CITY OF ALBUQUERQUE

**Re: Project Name – HLP Endodontics
10429 Lagrima De Oro NE
Traffic Circulation Layout**
Engineer's/Architect's Stamp dated ~~5-6-15~~ (F21-D063)
5-15-15

Re: HLP Endodontics, 10429 Lagrima de Oro NE.
Traffic Circulation Layout
Plan dated 04-23-15 (F21-D063)

The following is a list of our method of addressing your comments for our original submittal per your letter dated May 1, 2015.

1 site plan

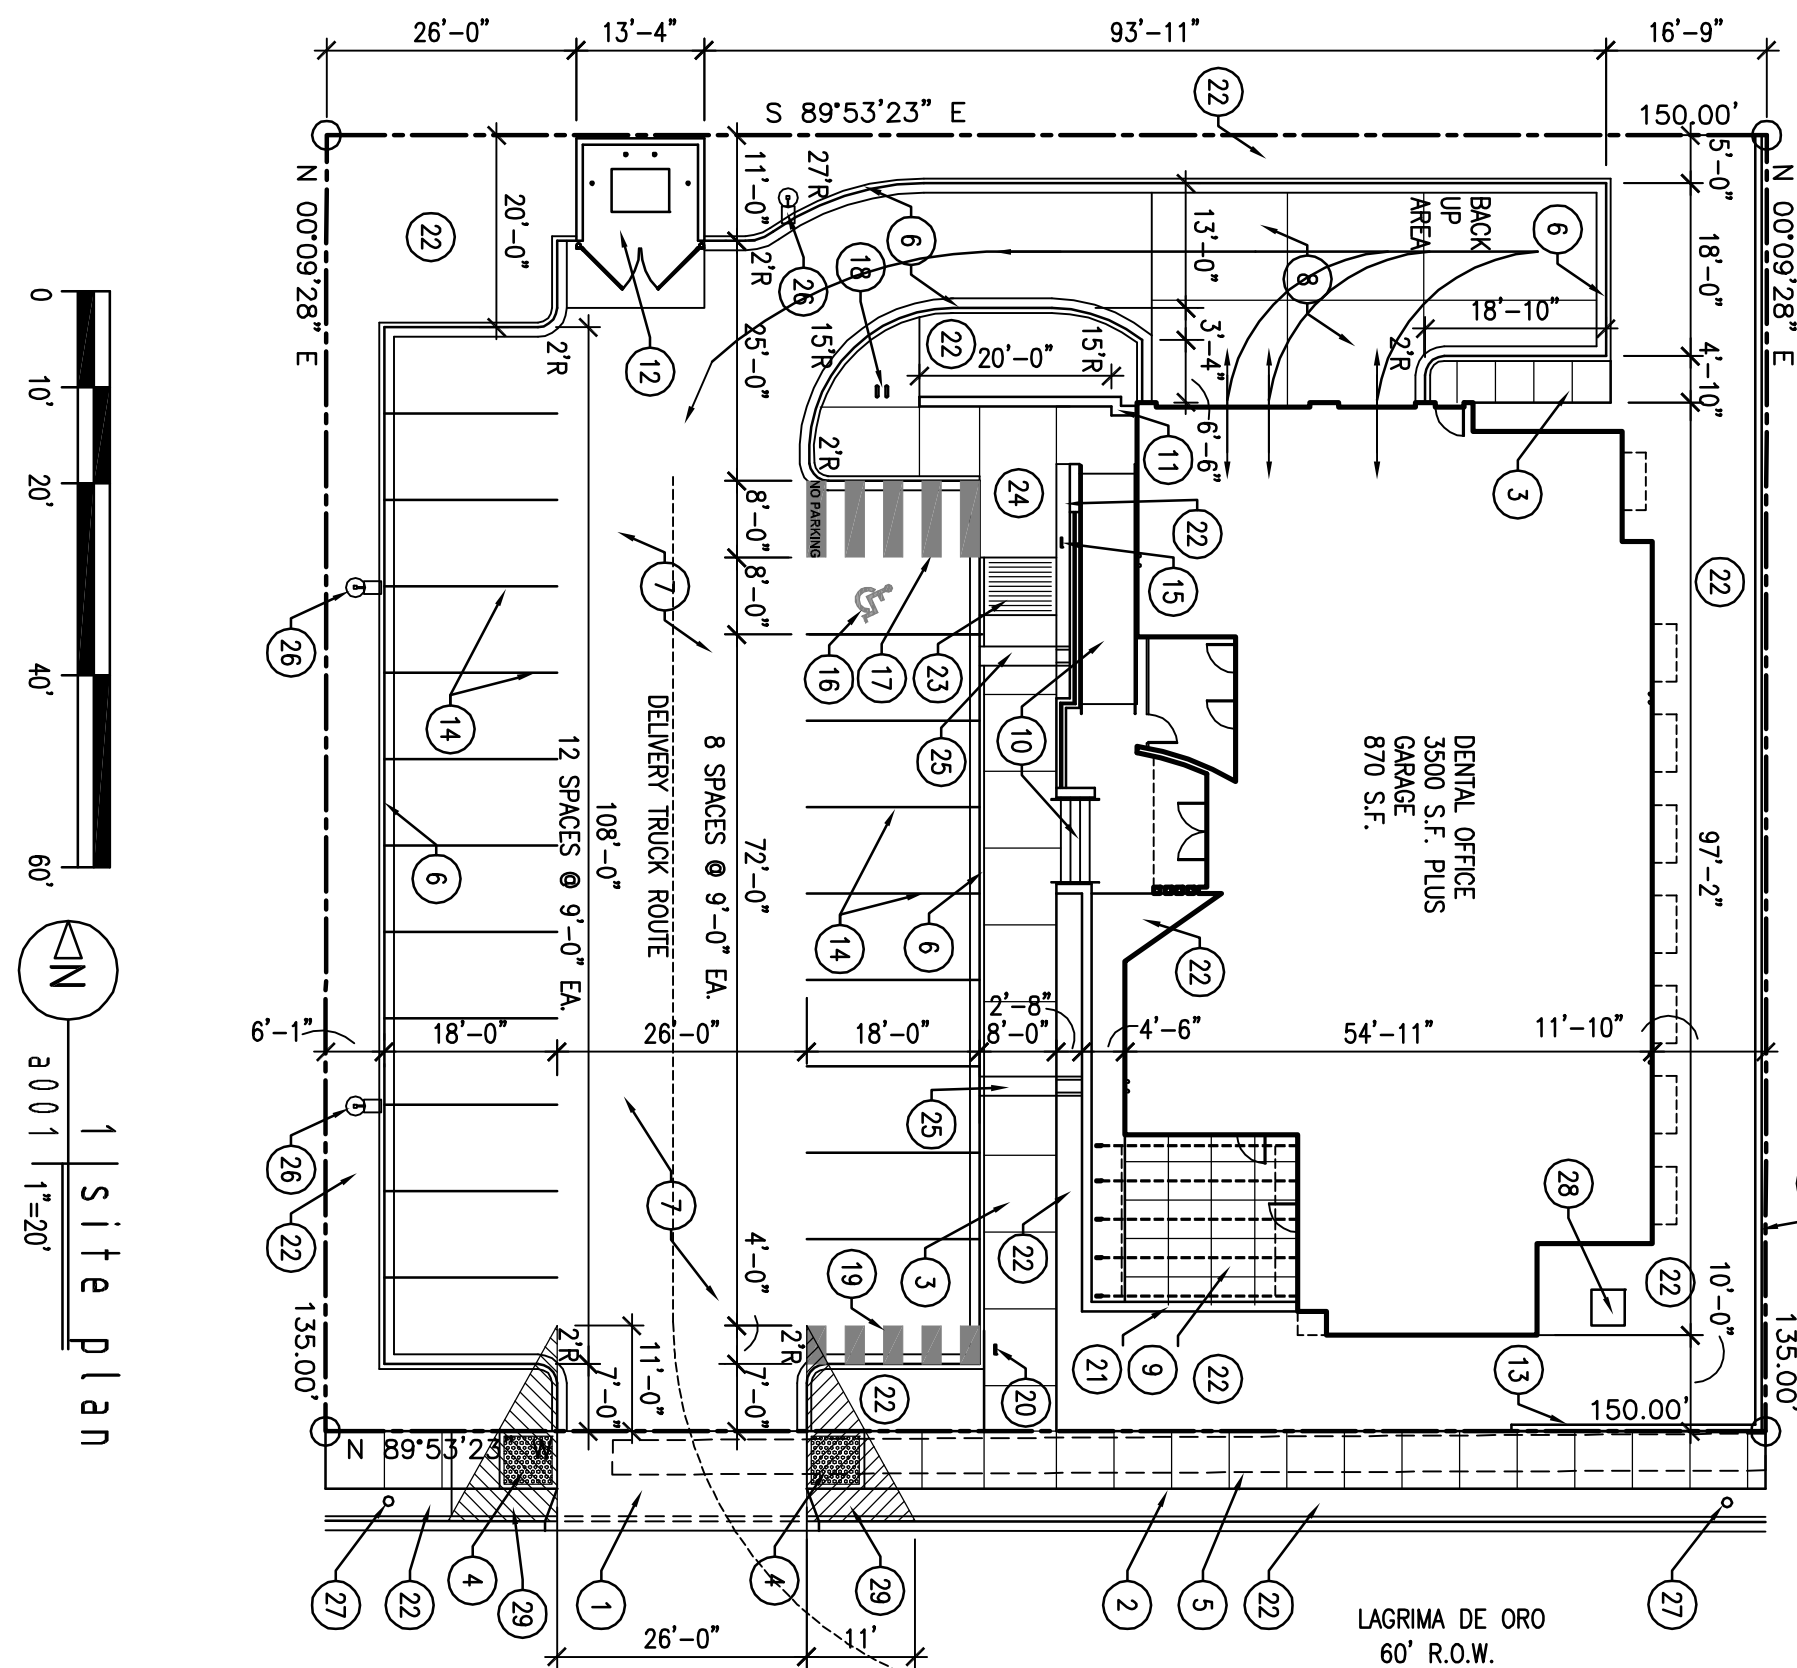
1. Site data has been added at the right side margin. The number of parking spaces required by the zoning code is listed as well as the other applicable code data.

2. R.O.W. width, street width and curb cut width on Lagrima de Oro have been added to the site plan.
3. The width of the parking spaces at the western edge of the property has been added to the site plan.

4. Keynote 19 at the south end of the parking row indicates motorcycle parking.
5. On detail 17/A001, "Violators are subject to a fine and/or towing" has been added to the sign detail.

6. The letters "NO PARKING" have been added to the accessible aisle. Note 17 has been changed accordingly.
7. The curb radii are shown on the site plan, including the north end of the building. As this is a small site, delivery trucks park along the curb on Lagrima de Oro, which is in keeping with the adjacent properties of the same size. For the purposes of this submittal, the delivery truck route onto the property has been shown. The Fire Marshal and Refuse Dept. have approved the site plan.

8. The accessible path from the public sidewalk is provided via the 8' sidewalk extending north to the ramp at the northwest corner of the building. This ramp then extends back south to the entry. The site has a substantial slope from east to west, which necessitates the stairs and ramp. The ramp has been widened to 6' as requested in comment 9.

9. The site plan has been revised to show 6' width at the ramp and the entire length of the accessible route.
10. As mentioned in item 7, the small size of the property preclude delivery truck circulation. As with the adjacent existing properties of similar size, delivery trucks park along the curb in Lagrima de Oro. Should a truck choose to enter the property, an access route is shown on the plan, however, it must be understood that this would require backing onto the street.

11. The clear sight triangle has been added to the site plan.
12. The note has been added to the site plan: keynote 29.
13. Keynote 1 has been revised to include COA dwg. numbers. Keynote 23 has been corrected to refer to detail 15. 12:1 slope has been added to keynote 2 of the enlarged entry plan.
14. It is understood that work in the public right of way requires a work order with DRC approved plans.
15. We have reviewed Chapter 23, section 6 of the Albuquerque Development Process Manual and according to sub category 8.b. two way driveways at local streets shall be 25' to 35' wide. The drivepad at 26' wide as shown is permissible.
